Disability Access Report

Project: Residential Development

Address: 60 Beaconsfield Street
Newport

Ref: J000378

Figure 1 - site plan and east elevation showing site slope

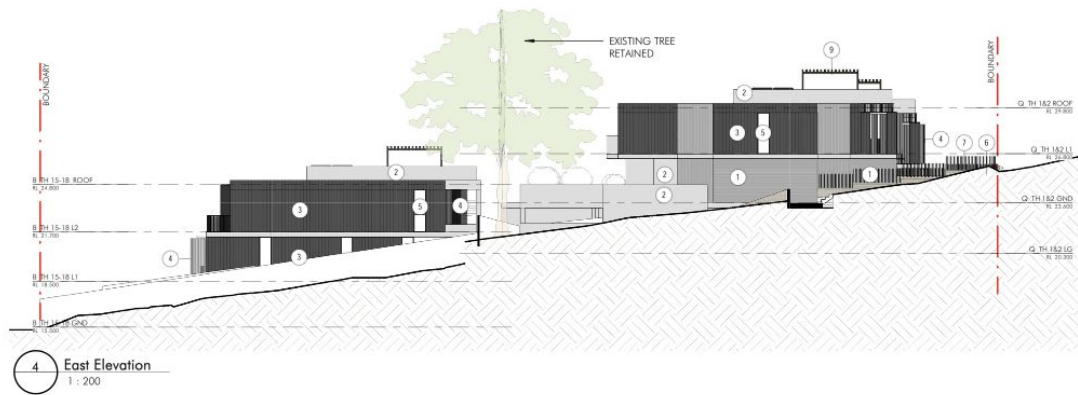
1. Pathways from Beaconsfield Street and Queens Parade to the principal entrances of the following townhouses: 9, 10, 11, 12, 13, 14, 15, 16, 17, 18 only. *Please note: Due to the natural topography along Queens Parade, that an accessible path of travel can not be provided to the entry doors of townhouses 1, 2, 3, 4, 5, 6, 7, 8.*
2. Access to and within common areas such as communal open spaces for the residents and waste deposit areas.
3. Access to the entrance doorway of sole occupancy units.

#	Non-compliance BCA Clause	Location of Non-compliance
1	D3.2	It is noted that due to the natural topography along Queens Parade, that an accessible path of travel can not be provided to the entry doors of townhouses 1, 2, 3, 4, 5, 6, 7, 8.

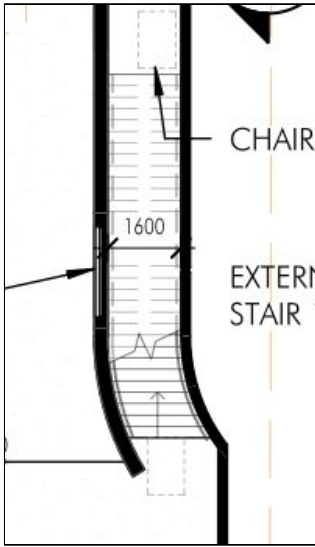
<p>Landscape plans provided show sufficient detail to assess AS1428.1-2009 compliant graded walkways are included in the paths of travel from the allotment boundary to the individual two adaptable unit entrances on Queens Parade and adaptable units on Beaconsfield Parade .</p> <p><u>Recommended Action</u> Accessible pathways (including communal areas) to comply with AS1428.1-2009:</p> <ul style="list-style-type: none"> ● Clause 6 - dimensions ● Clause 7 - slip resistance (AS/NZS 4586) ● Clause 7 - construction tolerances between abutment of surfaces ● Clause 10 - gradients, crossfalls and landings ● Clause 10 Ramp edging - kerb, kerb rail or other suitable ramp edging ● Clause 10 - handrails and handrails extensions ● Clause 11 - where there are stairs ● Clause 13 - where there are doors or gates <p>Stairs Plans for the Beaconsfield St basement level to courtyard level shows that vertical circulation is proposed to be via stairs. It is proposed that the one (1) flight of external stairs 1 from the Beaconsfield basement level is to include a stairway platform chair lift of 1600m with.</p> <p>There is another set of external stairs 2 from the beaconsfield car parking area to link to the proposed common area.</p> <p>Within the central courtyard there are sets of stairs proposed.</p> <p><u>Recommended Action</u> All non-fire-isolated stairs to comply with AS1428.1 Cl 11 Stairs (2009) with regards to</p> <ul style="list-style-type: none"> ● Minimum width between handrails of 1000mm ● Note greater minimum width of 1600mm

<p>required on stairs within platform lift</p> <ul style="list-style-type: none"> ● Handrails on both sides ● Handrail heights to be 865mm to 1000mm above step nosing ● Handrail extensions at top and base ● Tactile indicators on top and bottom landing of steps ● Tactile indicators on mid point landings where handrails are not continuous on both sides of landing ● Single solid contrast strips to edge of stair nosings 50 - 75mm deep (30% contrast) <p>Stairs - fire-isolated</p> <p>No fire-isolated stairs are shown on the plans.</p> <p><u>Recommended Action</u></p> <p>Where provided, Fire isolated stairs to have</p> <ul style="list-style-type: none"> ● Single solid contrast strip to edge on stair nosings 50-75mm deep (30% contrast) to comply with AS1428.1 ● handrail at 865mm to 1000mm above step nosing on at least one side of the stairs to comply with AS1428.1 (2009) ● Handrail extensions at landings where the handrail is not continuous ● Handrails to have no vertical sections <p>Lifts</p> <p>Each adaptable dwelling contains either a lift providing access from the basement level up to the highest residential level. Lift access is not provided to the individual rooftop terraces as balcony access is provided on levels with lift access.</p> <p>A stairway platform chair lift is proposed between the Beaconsfield Street carparking level and the central courtyard (see also section D3.1, D3.2 and E3.6 of this table)</p> <p><u>Recommended Action</u></p> <p>At time of Construction Certificate, ensure:</p> <ul style="list-style-type: none"> ● compliance with
